21 March, 2008

**Proposed amendments to ECE/TRANS/GRE/2008/7(Regulation No. 48)**

Fig. 1

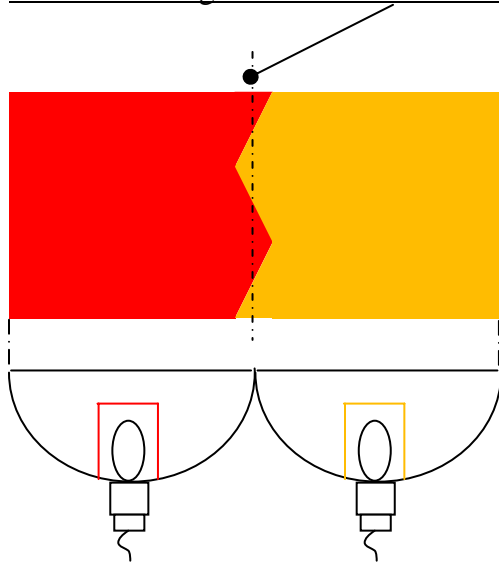
Lamps, in which stop lamps and direction indicator lamps are grouped like Fig. 1, are prohibited. In contradiction with that, lamps, in which stop lamps and direction indicator lamps are reciprocally incorporated like Fig. 2, are permitted in ECE/TRANS/GRE/2008/7 new paragraph 5.7.1.1. Japan is of the opinion that stop lamps and direction indicator lamps should not be permitted to be reciprocally incorporated as mentioned in GRE-56-22.

A vertical straight line intersects more than two borderlines.

5.7.1.2. **Stop lamps and direction indicator lamps are not permitted to be reciprocally incorporated.** Where stop lamps and direction indicator lamps, are **combined or** grouped, any horizontal or vertical straight line passing through the projections of the apparent surfaces of these functions on a plane perpendicular to the reference axis, shall not intersect more than two borderlines separating adjacent areas of different colour. "
